ADDENDUM NO. 5 TO PROJECT NO. 45124

**CONSTRUCTION WORK, HVAC WORK, PLUMBING WORK, AND ELECTRICAL WORK
ABATE HAZARDOUS MATERIALS
AND RENOVATE BUILDING NO. 4
STATE OFFICE BUILDING CAMPUS
1220 WASHINGTON AVENUE
ALBANY, NY**

October 14, 2016

HAZMAT
QUANTITY

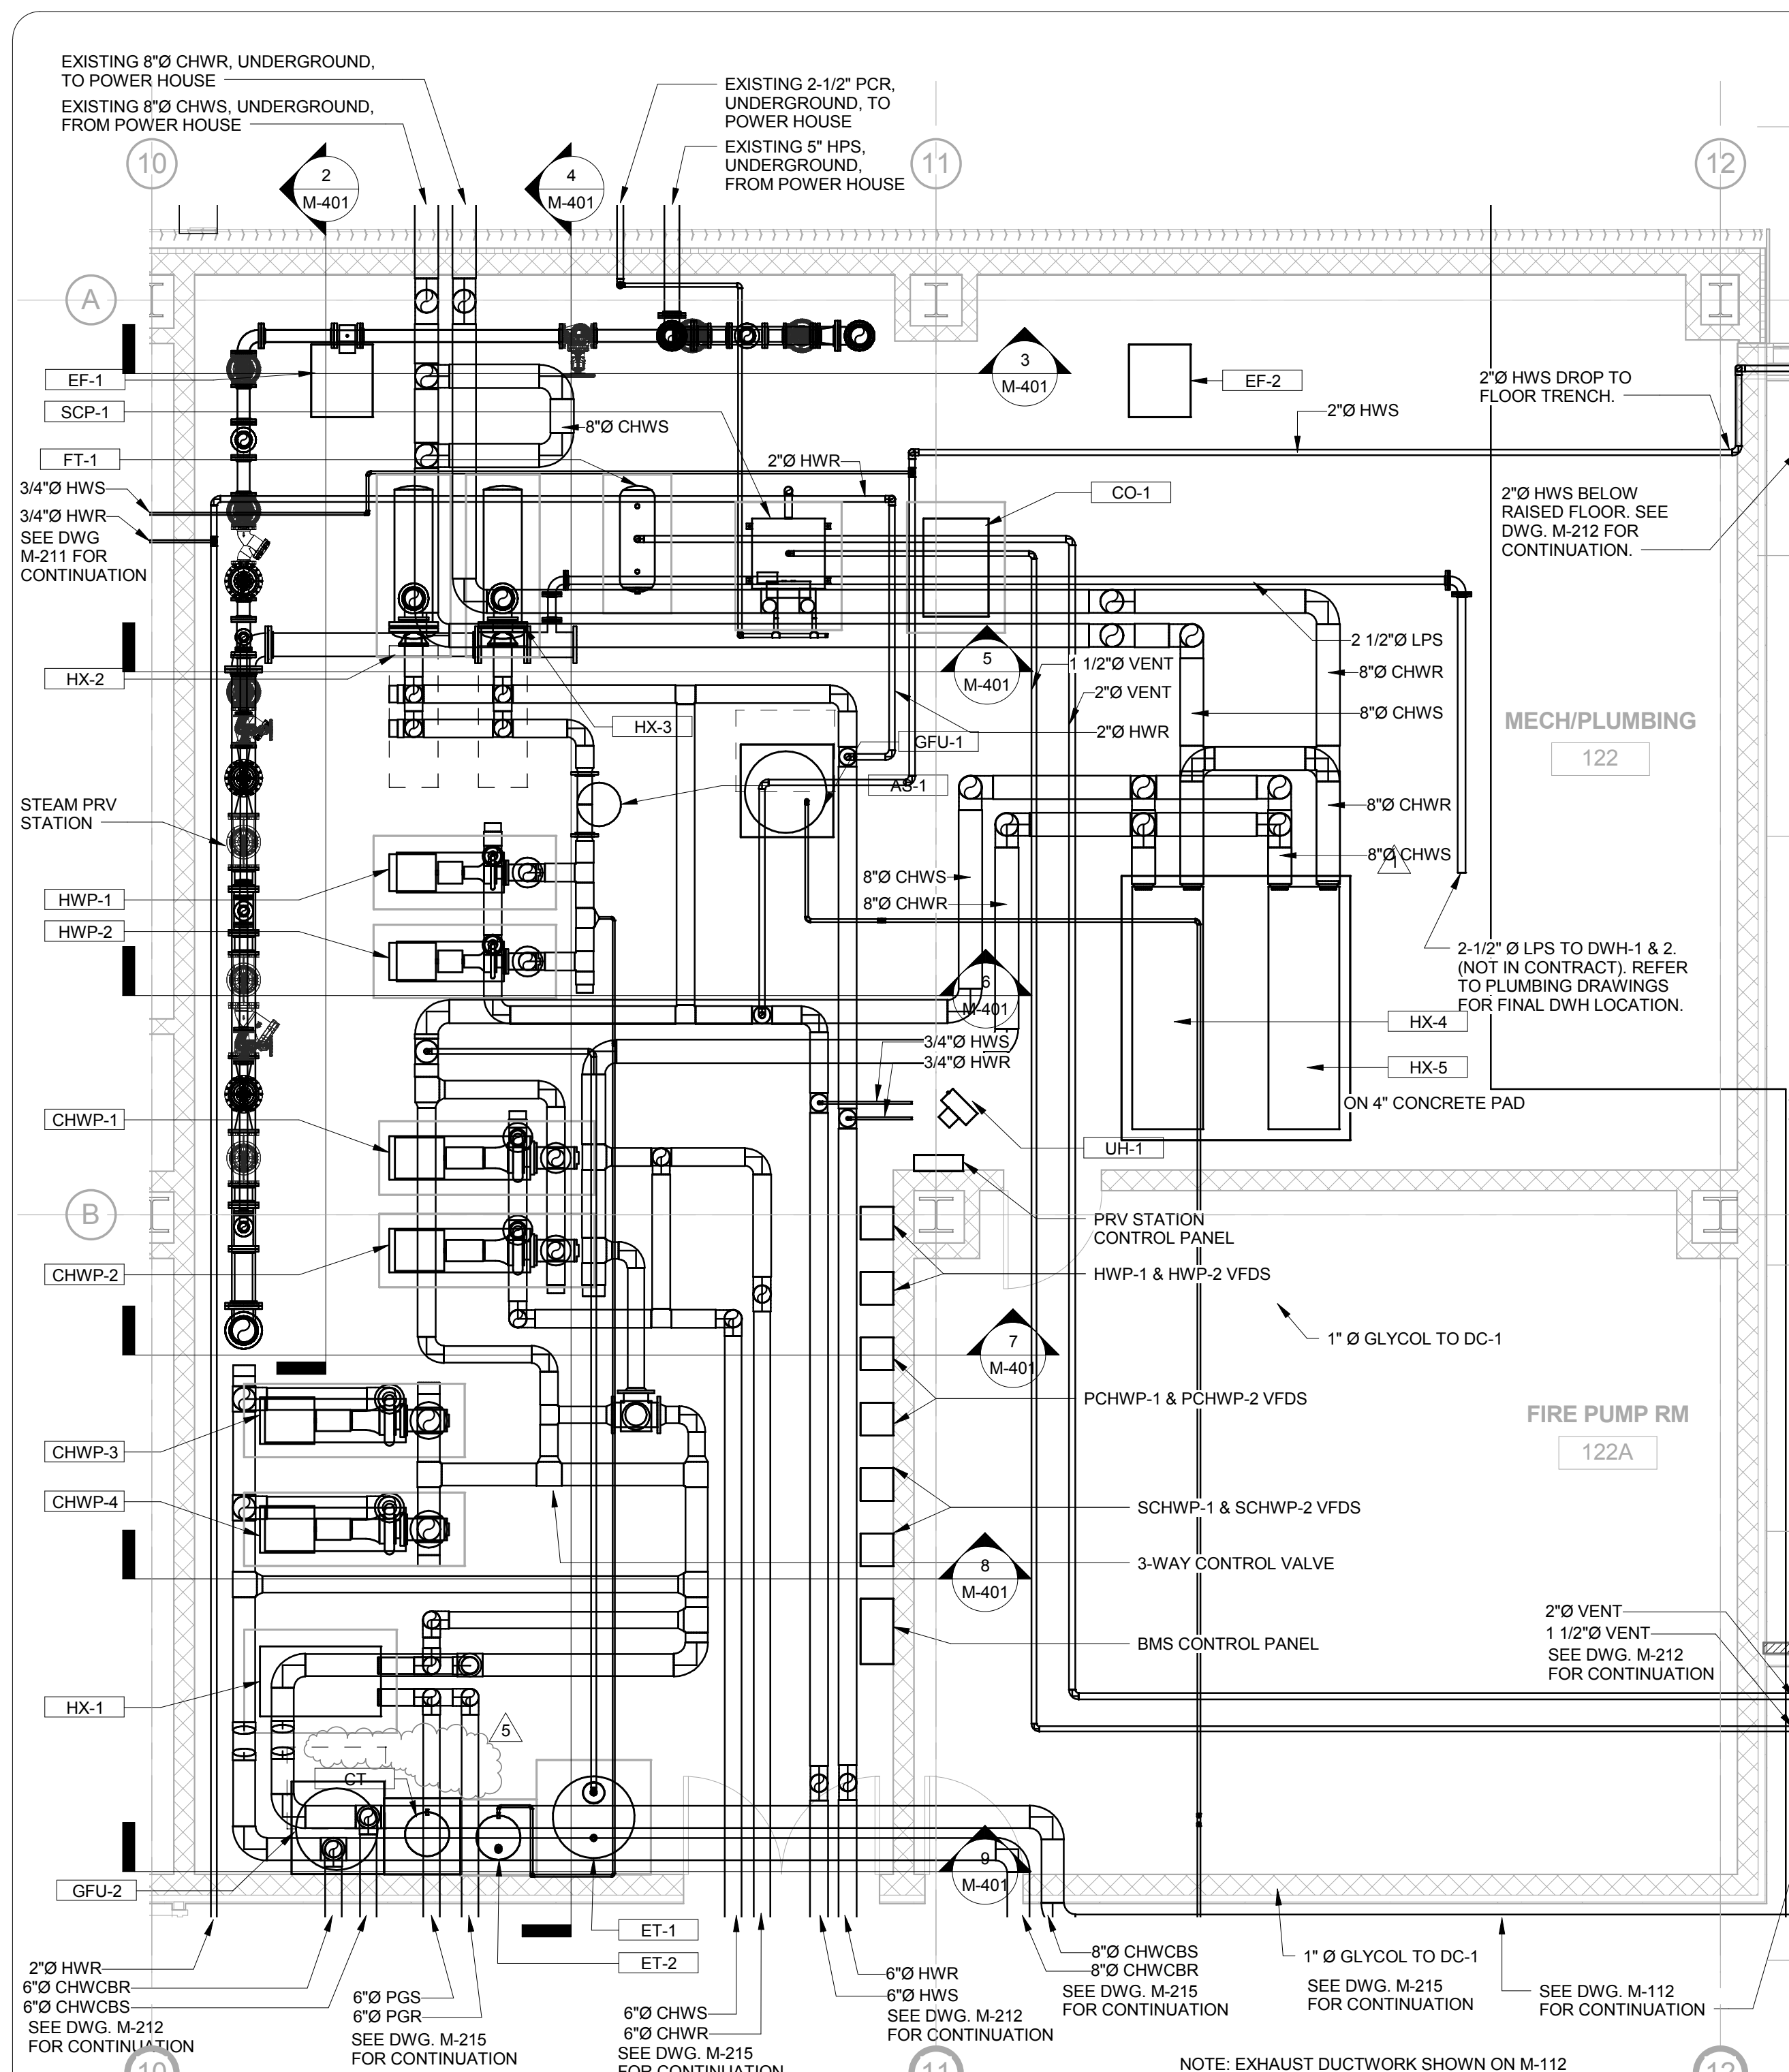
46. Revised Drawings:
- a. Drawing No. H-101 noted “REVISED DRAWING 10/13/16” accompanies this Addendum and supersedes the same numbered originally issued Drawing.
